NSRP #0349
May 1992

P-52 Balloting of Hull
and
Mechanical Standards

Panel SP-6

PROJECT P-52
STATUS SUMMARY
5/28/92

FIGURE 3

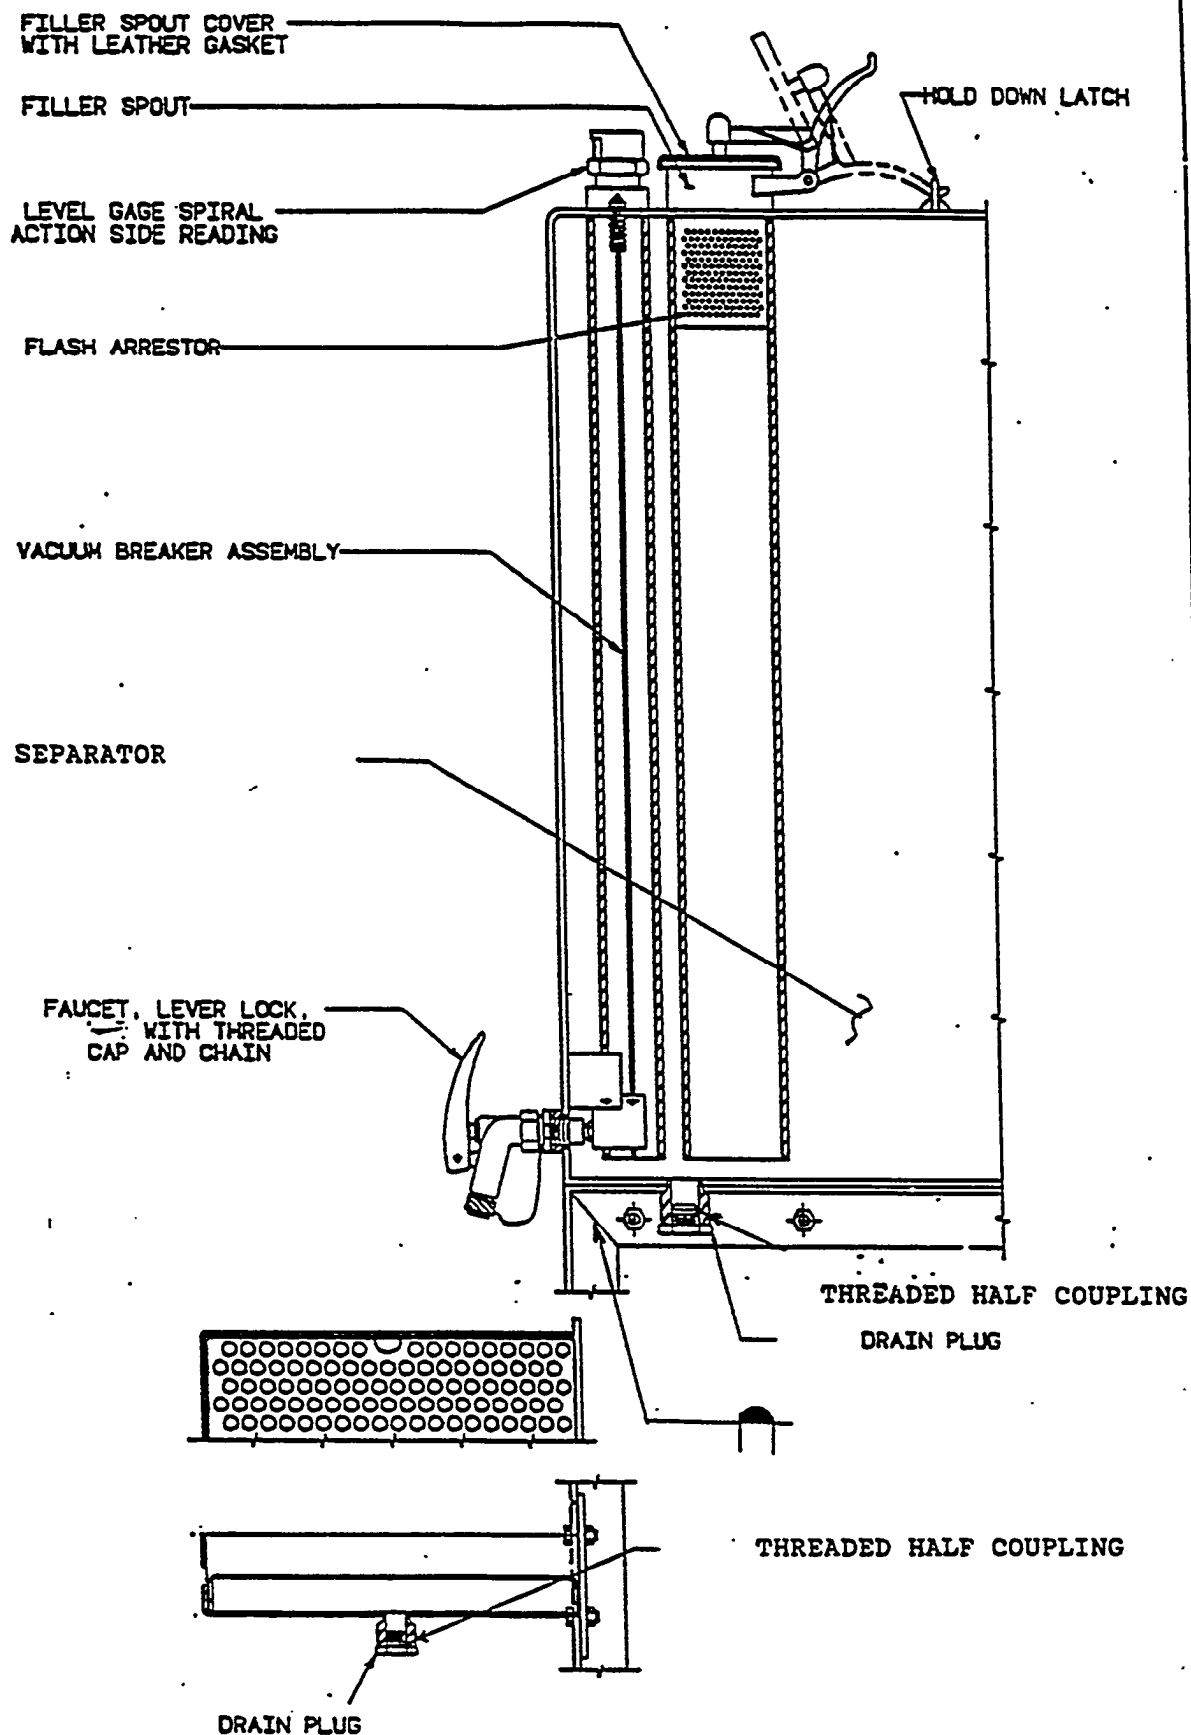
13. Fig. 3 - Under Label revise to show (See 6,4).	Concur
<u>Chas Sinche (JJH)</u>	<u>(90-2 MCLB)</u>
14. Para 5.2.1 - Delete last weight. This is purely a function of the amount of liquid in the tank - In addition we state the tanks aren't to be filled with water.	Non-Concur - Since S.G. of water Is 1 and since 95% of liquids to be used is less than 1, we are using this as a factor of safety. The weights are correct.

FIGURE 1. CLEAT PAD, MARINE HARDWARE

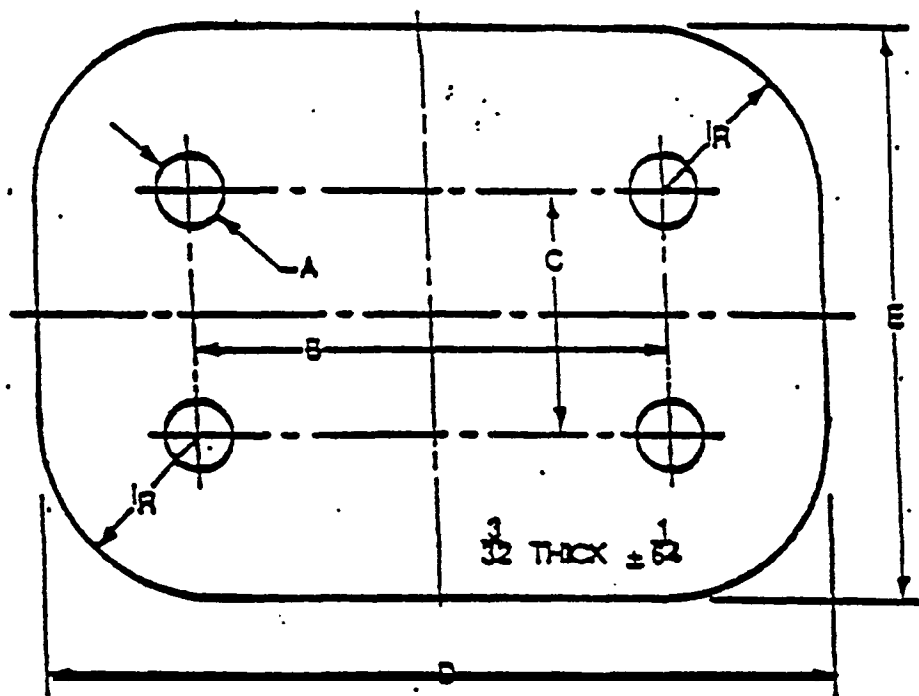
| 12 Figure 1-Dimension extension . lines should not cross. | Disagree - This will not harm the spec . |

3. In Figure 1, change Figures under "M" to 1 3/8".

FIGURE2 CLEAT, MARINE HARDWARE

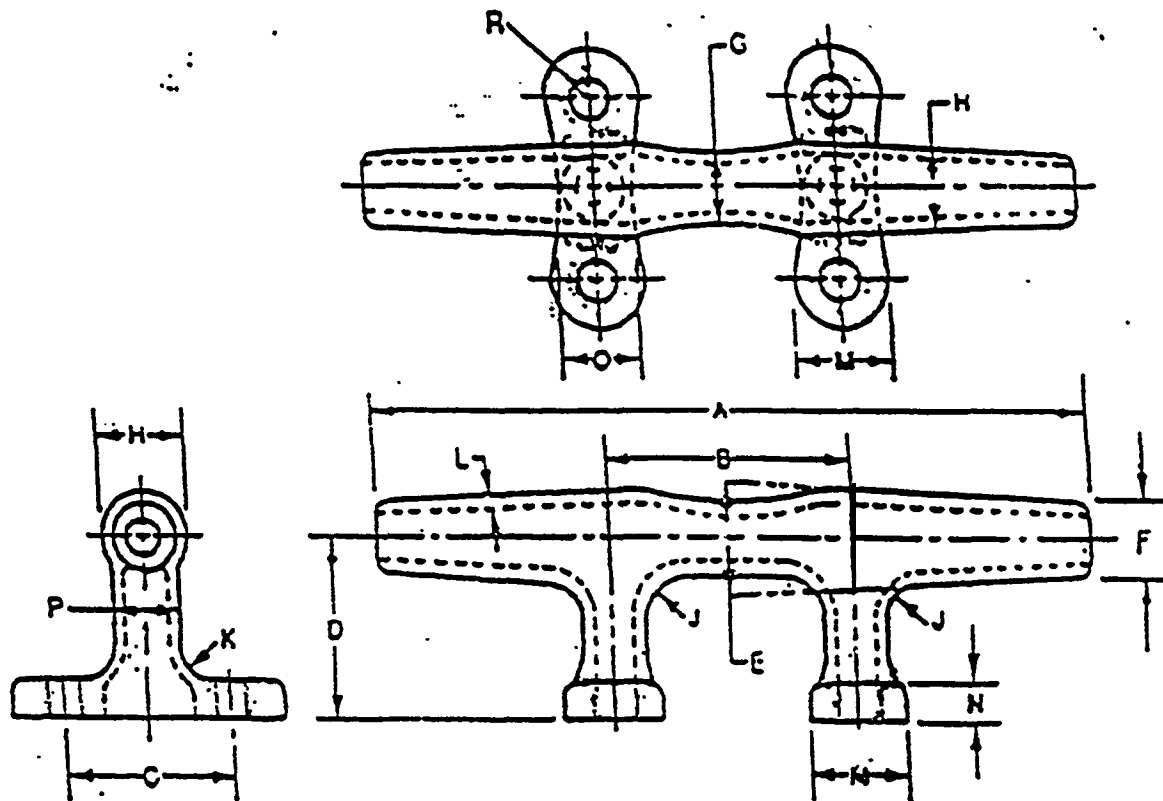
11. Figure 2 - Delete "Hollow".

28. Questionable whether F593 is correct, since Fig.2 is shown as drilled & counter-sunk making flat or CSK head mach. screws.... Concur - Modified Fig.2 to suit.

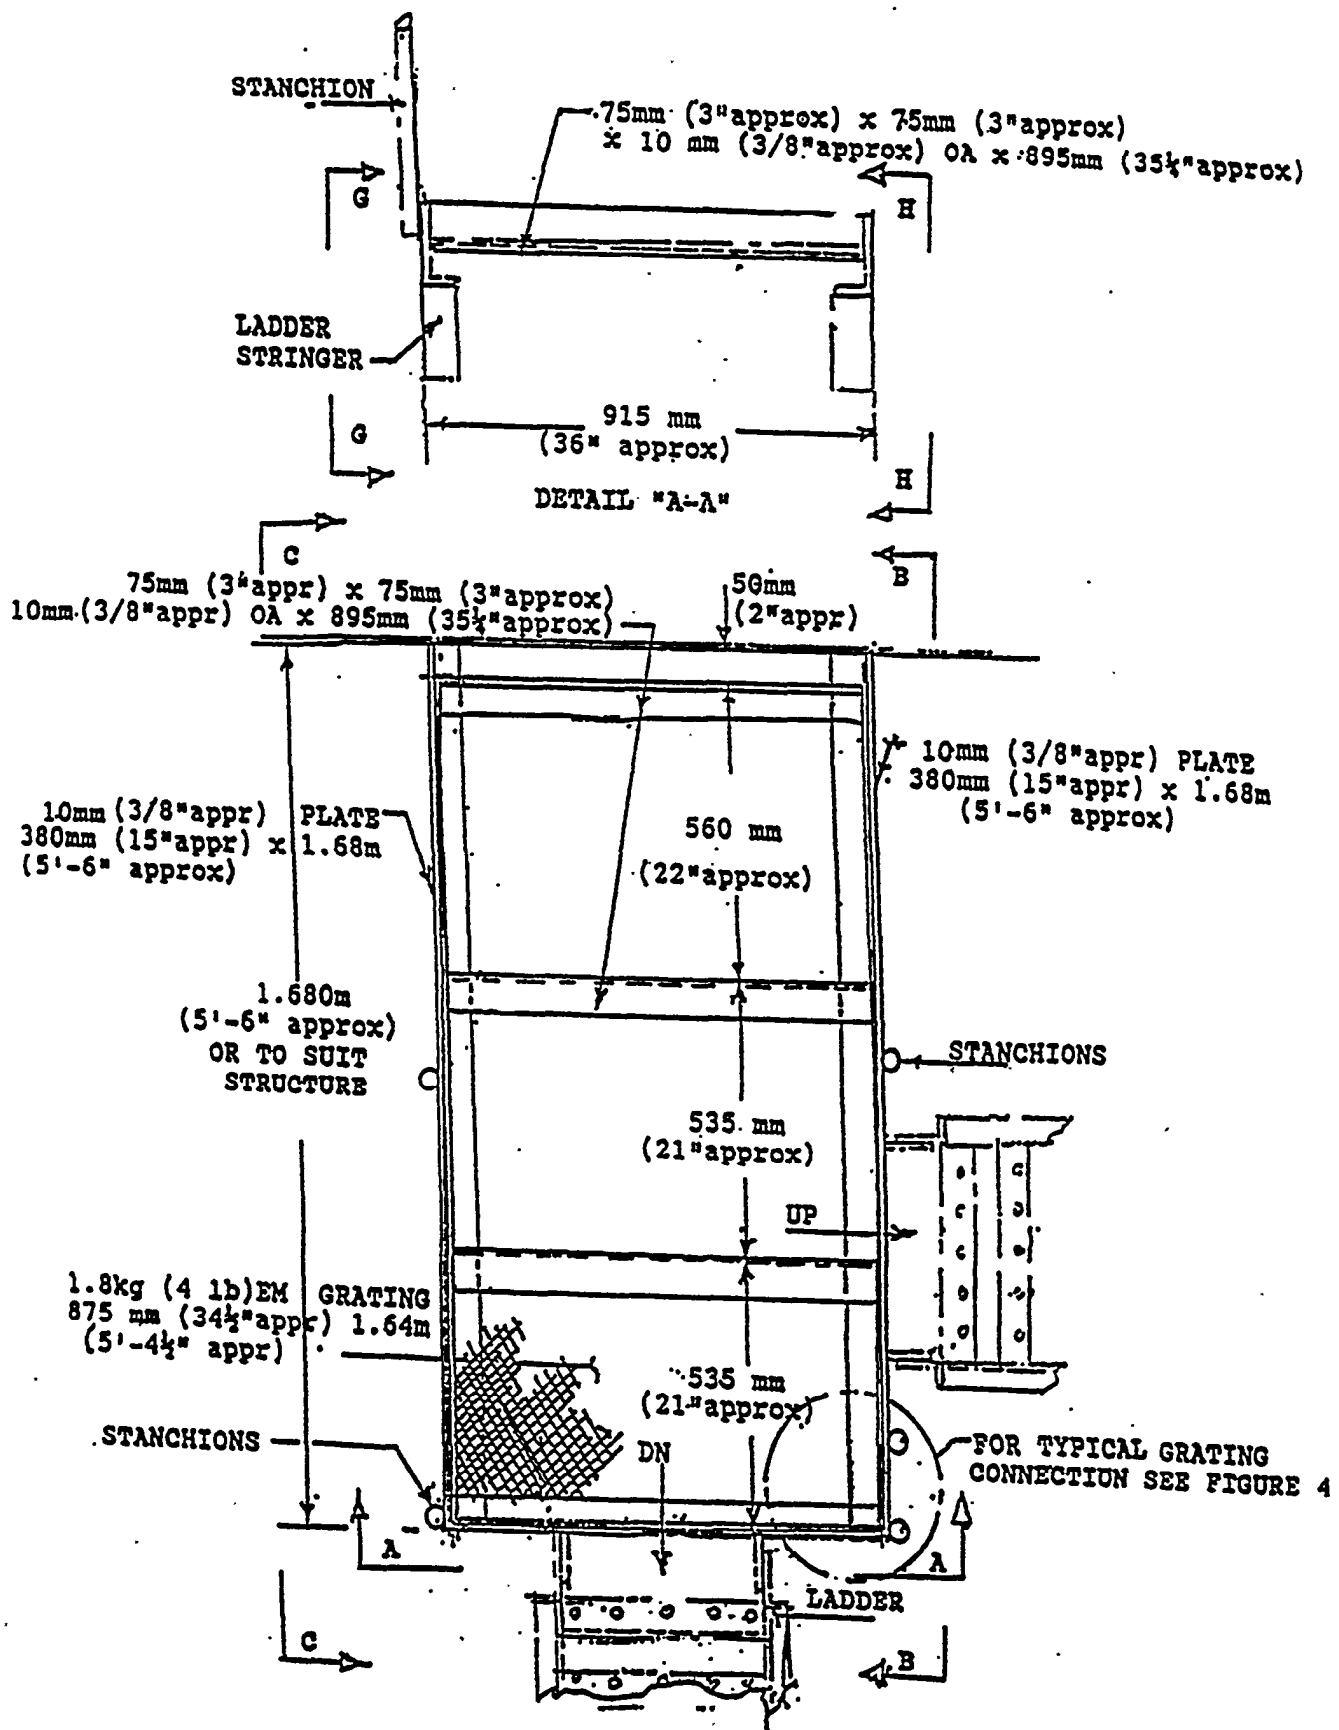
20. Fig.1 - Change all 9.5mm to 9mm.

FIGURE 2

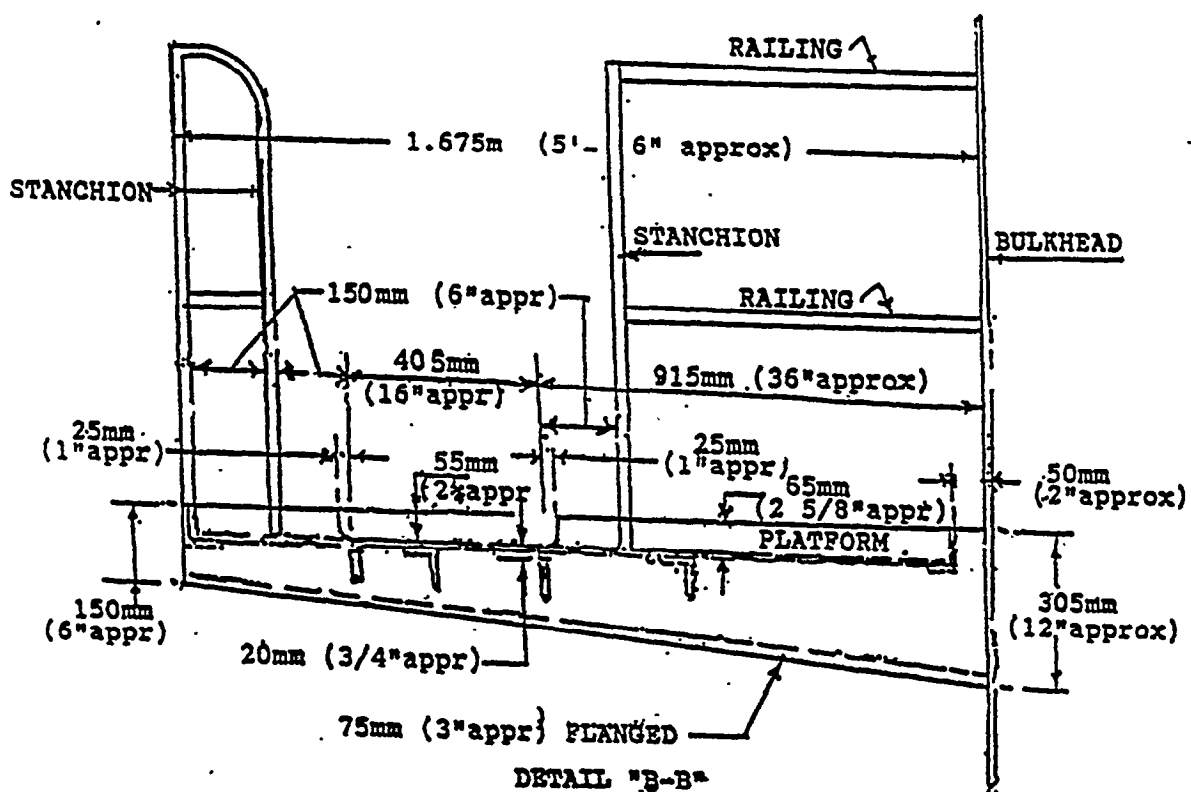
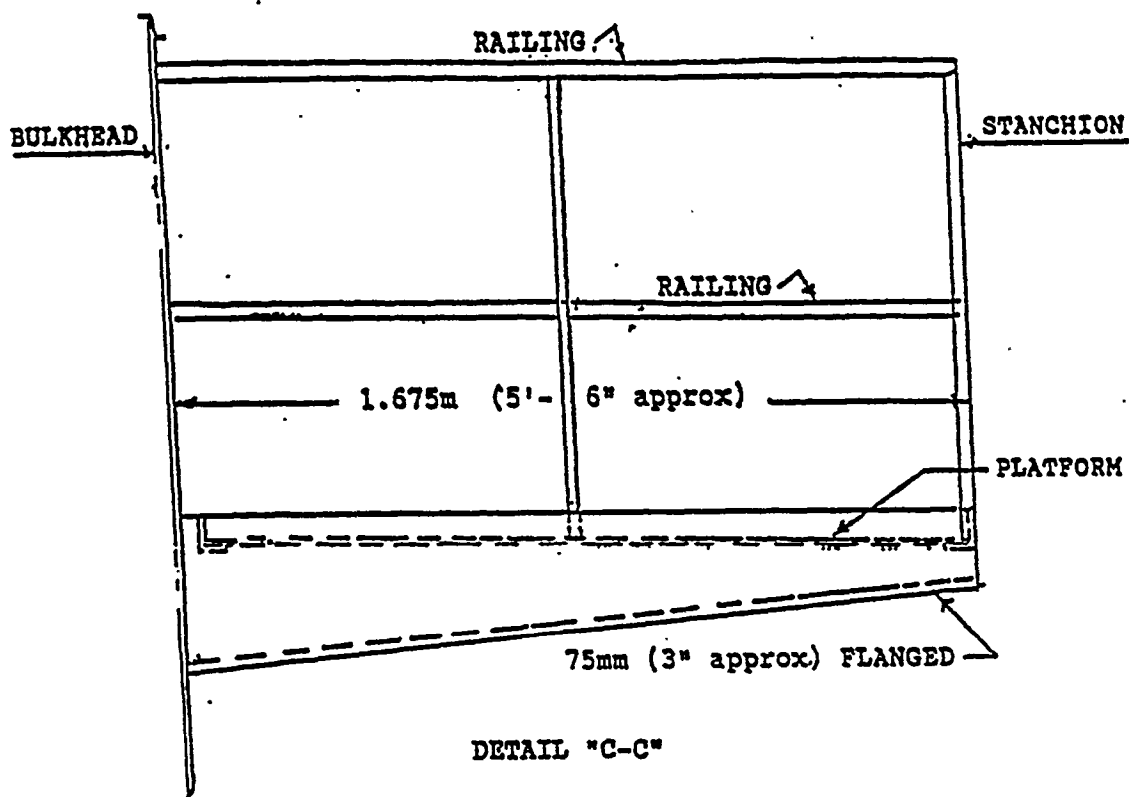
21. Fig. 2 - Change "406" to "405".

FIGURE 3

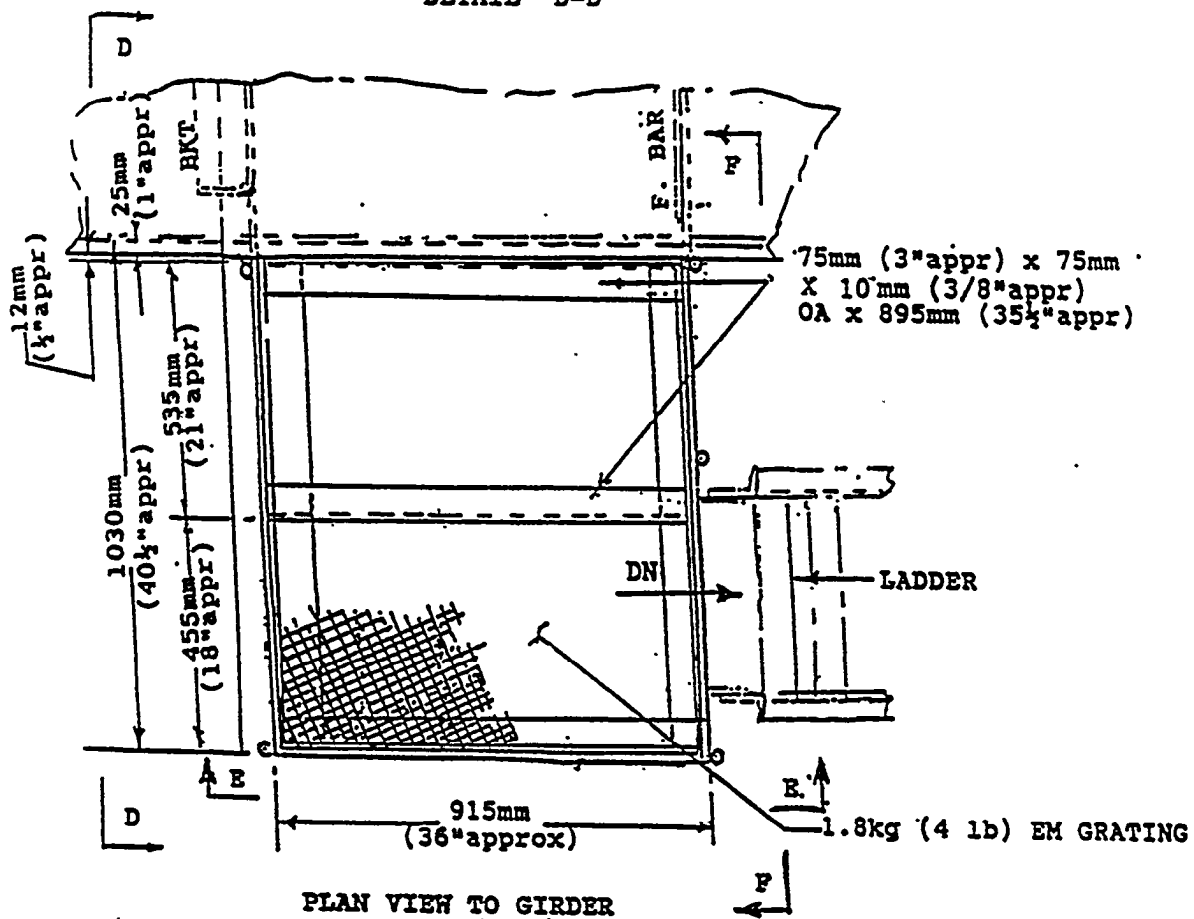
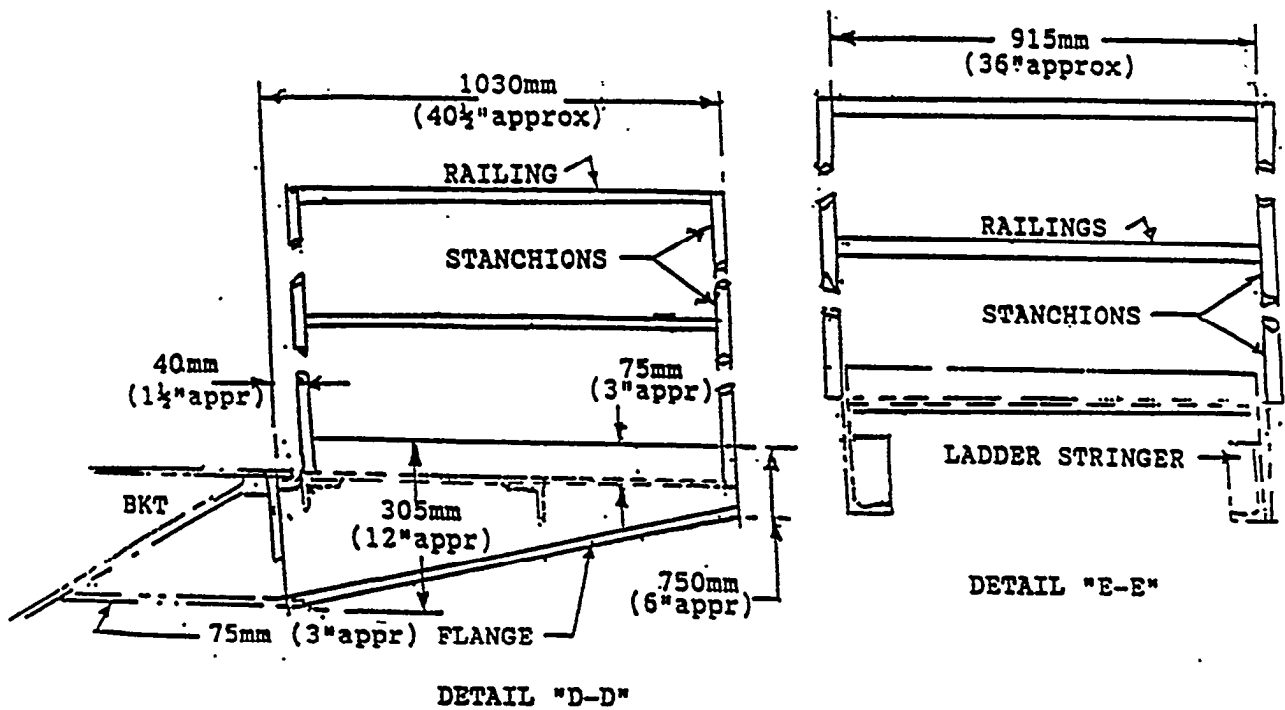
22. Fig..3 - Change 1028 to 1030. 38mm to 40mm, 458mm to 455mm, & 533mm to 535mm.
